GE
159 Plastics Avenue
Pittsfield, MA 01201
USA

May 4, 2006

**Re: GE-Pittsfield/Housatonic River Site
Newell Street Area II (GEC450)
Proposal for Engineered Barrier Modifications**

SITE RESTORATION PLAN

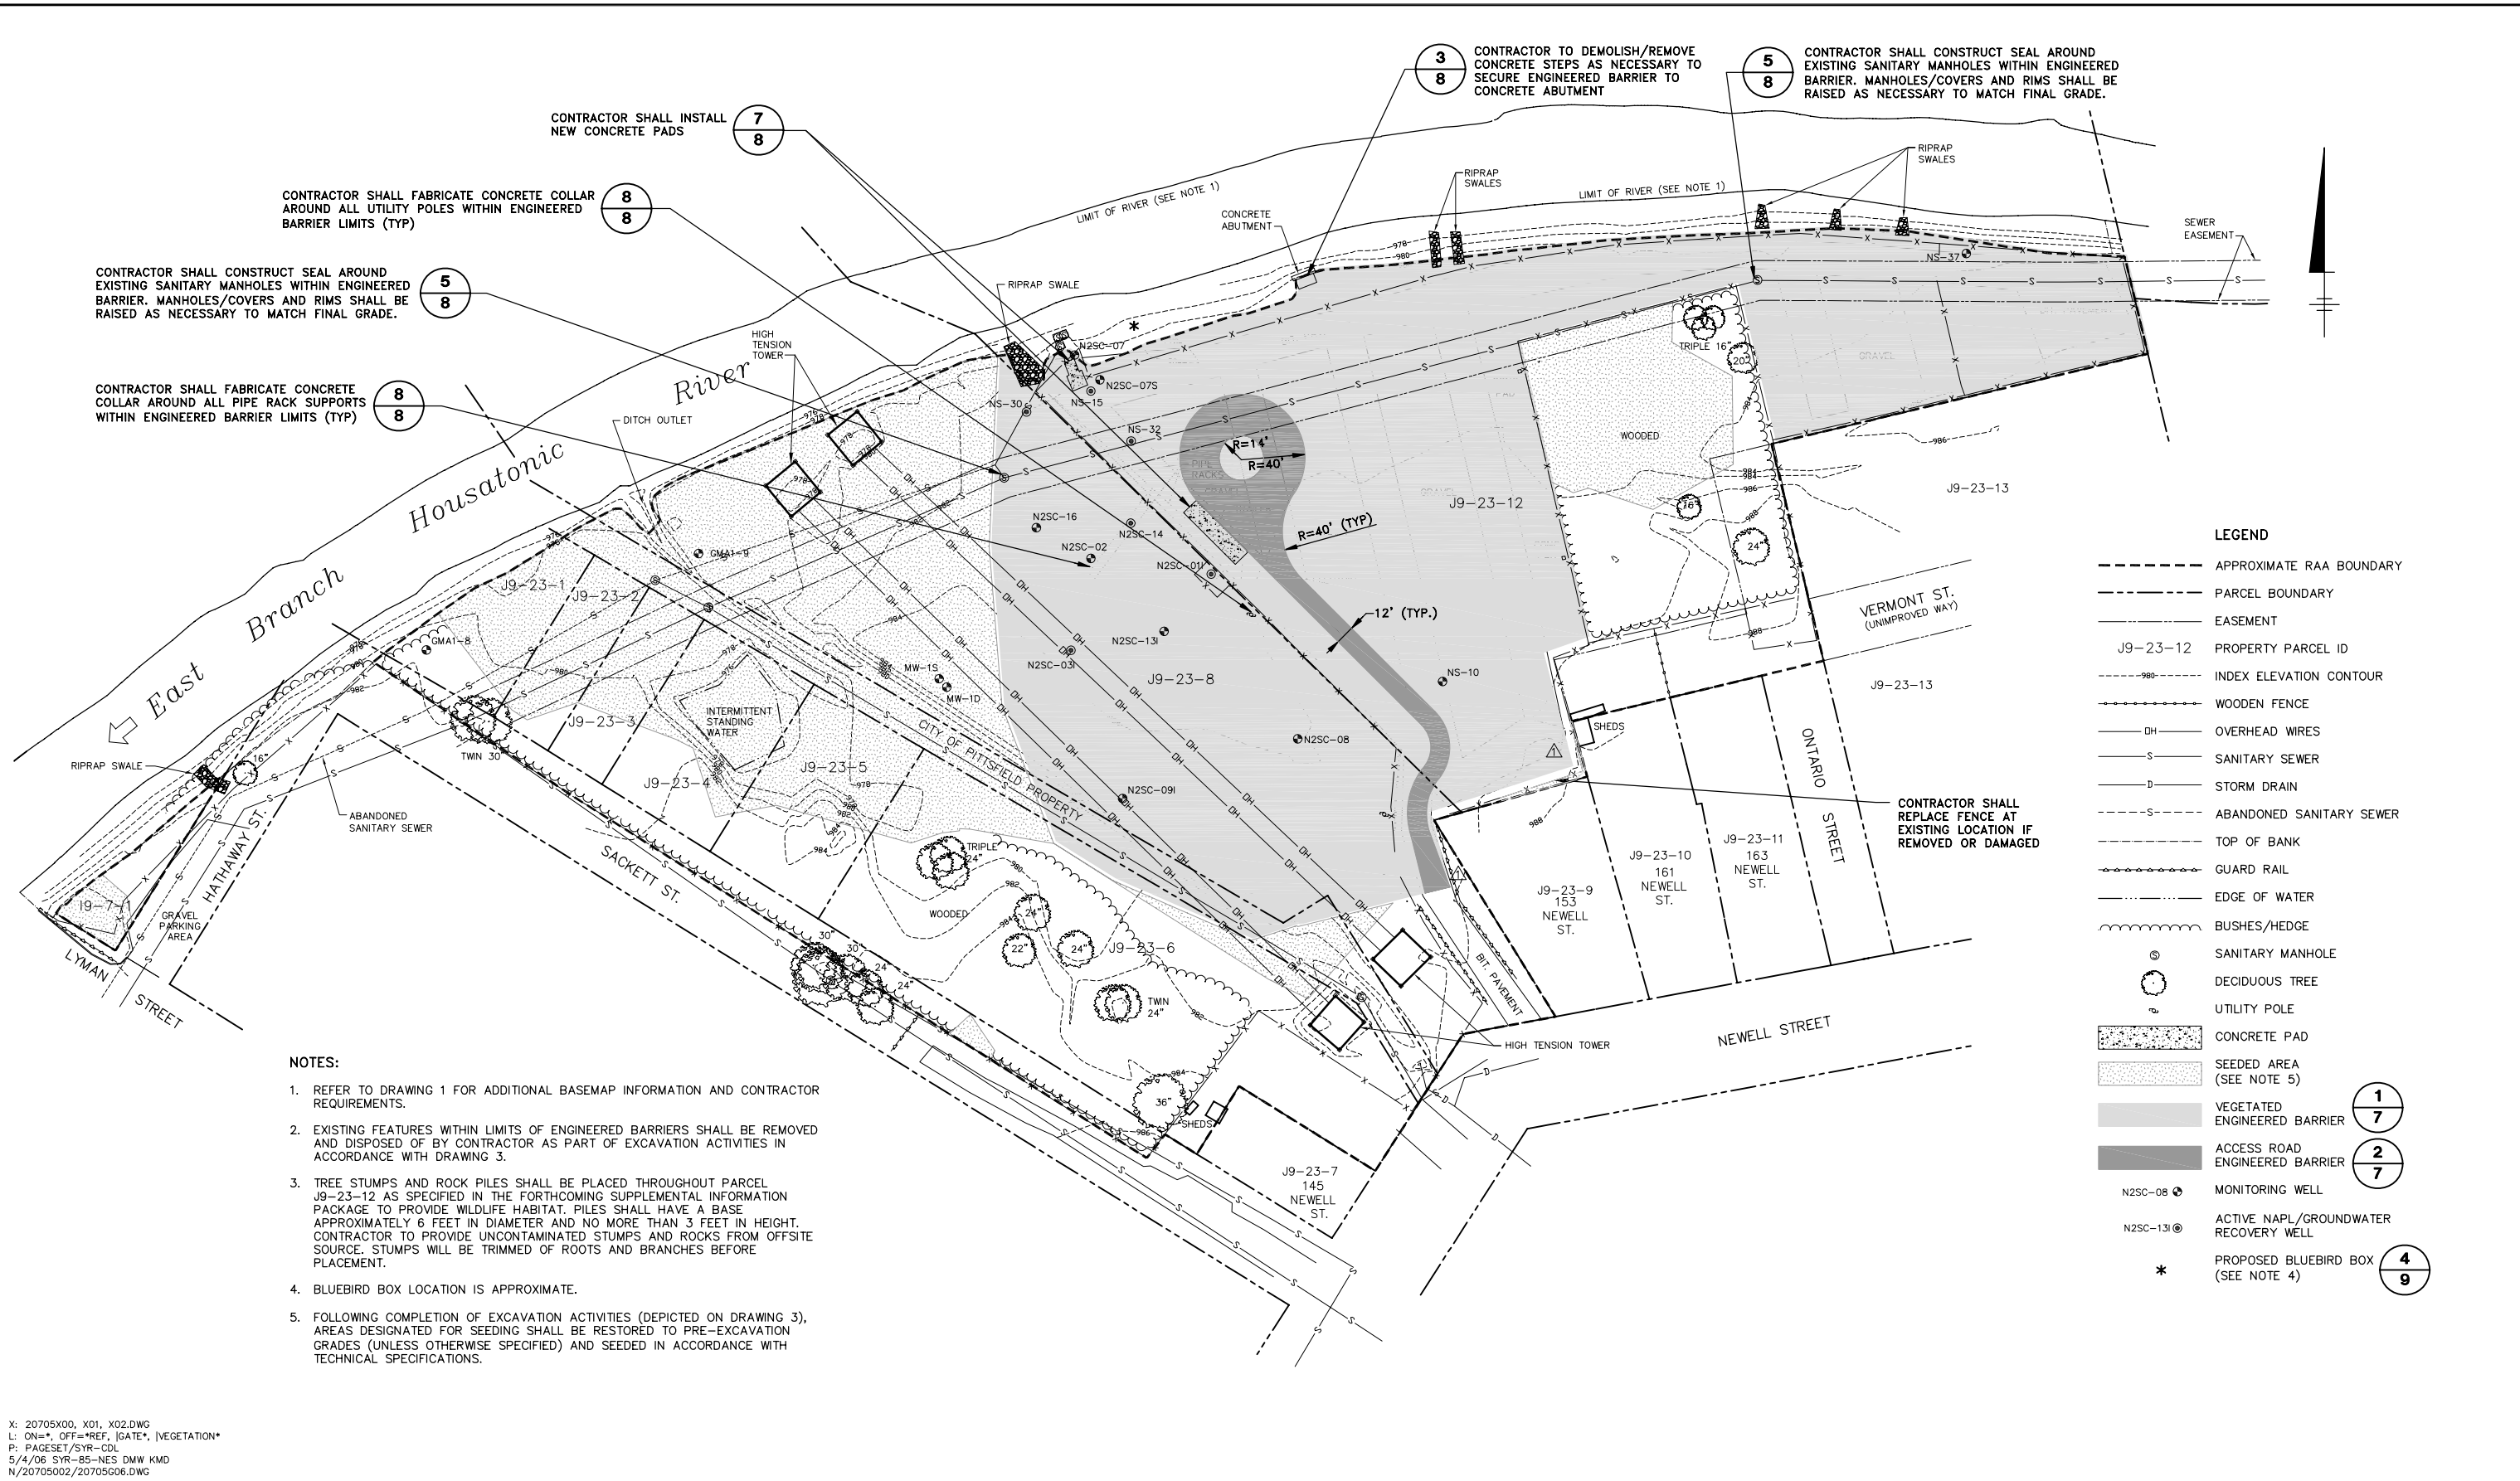
4/21/06	REVISED LIMIT OF VEGETATIVE ENGINEERED BARRIER INSTALLATION	CAA
Date	Revisions	Init

GENERAL ELECTRIC COMPANY • PITTSFIELD, MASSACHUSETTS
 NEWELL STREET AREA II RAA REMEDIAL ACTION
ENGINEERED BARRIER PLAN
SUBGRADE
 TECHNICAL DRAWINGS

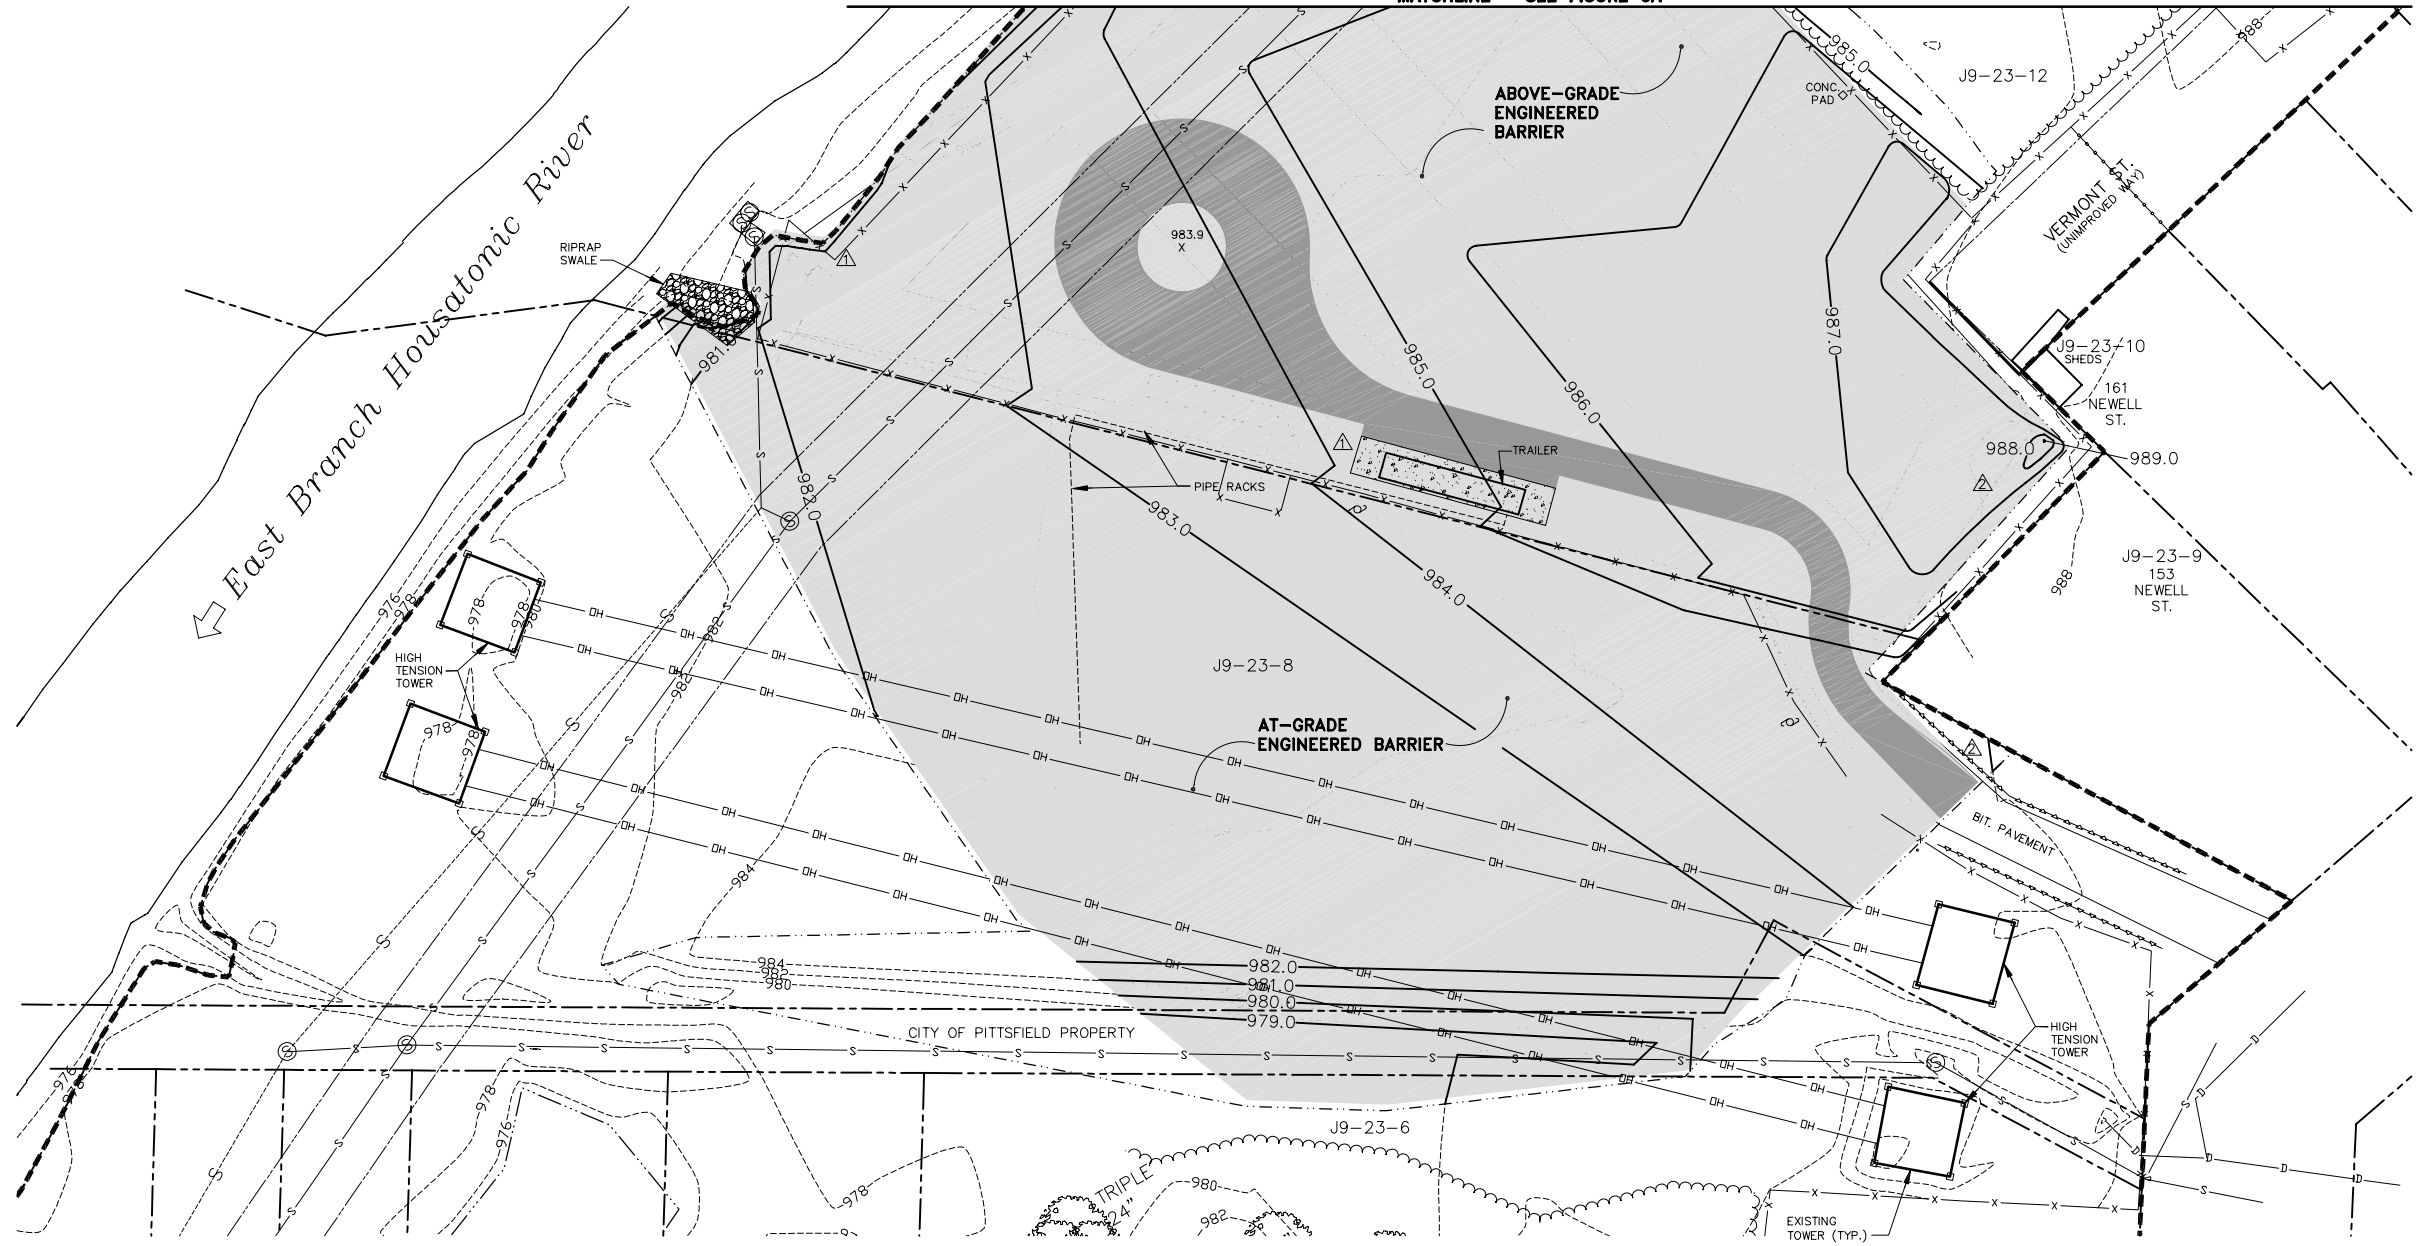
Date	Revisions	Init
4/21/06	REVISED LIMITS OF VEGETATIVE ENGINEERED BARRIER, PROPOSED CONTOURS, AND LIMIT OF GRADING	CAA
8/12/05	REMOVED SHED, REVISED LOCATION OF TRAILER, AND PIPE RACKS

ENGINEERED BARRIER PLAN FINAL GRADE

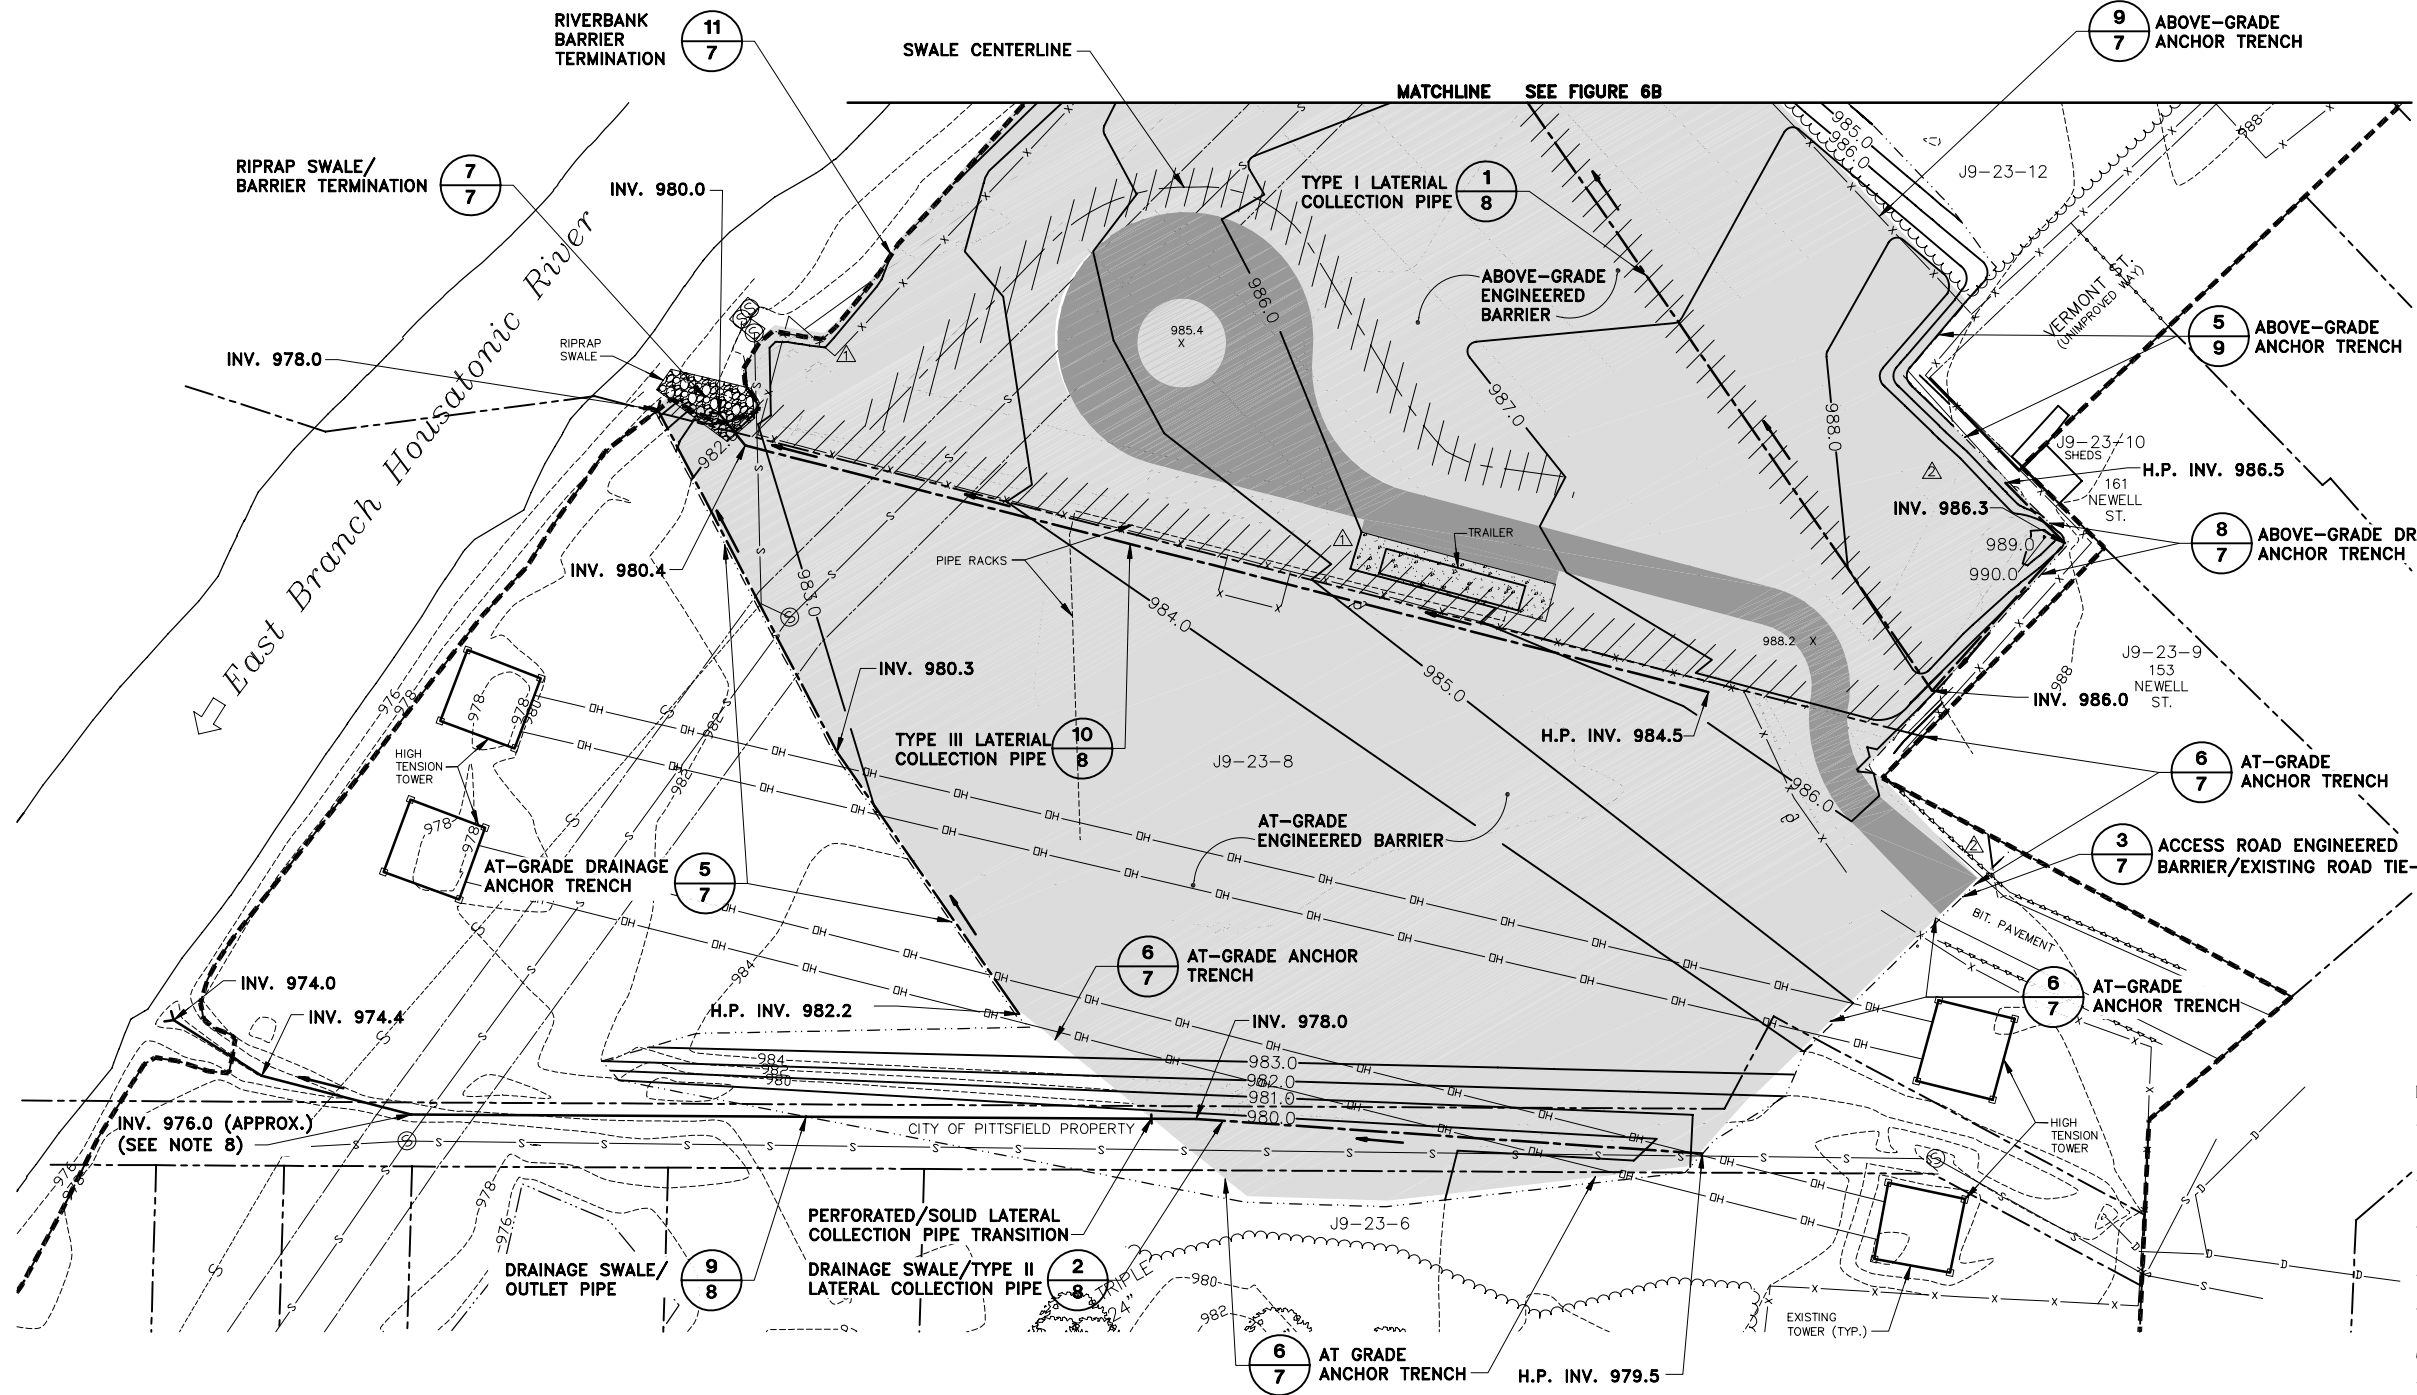
Date	4/21/06	REVISED LIMITS OF VEGETATIVE ENGINEERED BARRIER, PROPOSED CONTOURS, LIMIT OF GRADING, AND BARRIER COLLECTION PIPE	CAA
Date	8/12/05	REMOVED SHED, REVISED LOCATION OF TRAILER, PIPE RACKS, AND SURROUNDING GRADES

ABOVE-GRADE DRAINAGE ANCHOR TRENCH 8

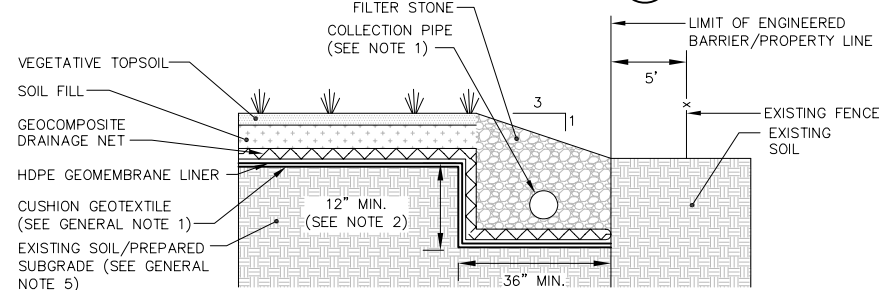
Date	4/21/06	Revisions	REVISE DETAIL 8	CAA
Date		Revisions		CAA

ABOVE-GRADE ANCHOR TRENCH 5
NOT TO SCALE

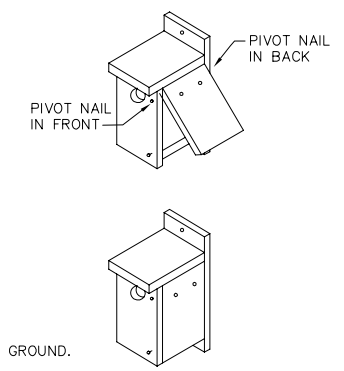
Date	Revisions	CAA	ACC
4/21/06	ADD DETAIL 5	CAA	ACC
7/6/05	FRONT OF BIRDHOUSE WIDTH CHANGED TO 6 1/2"	CAA	ACC
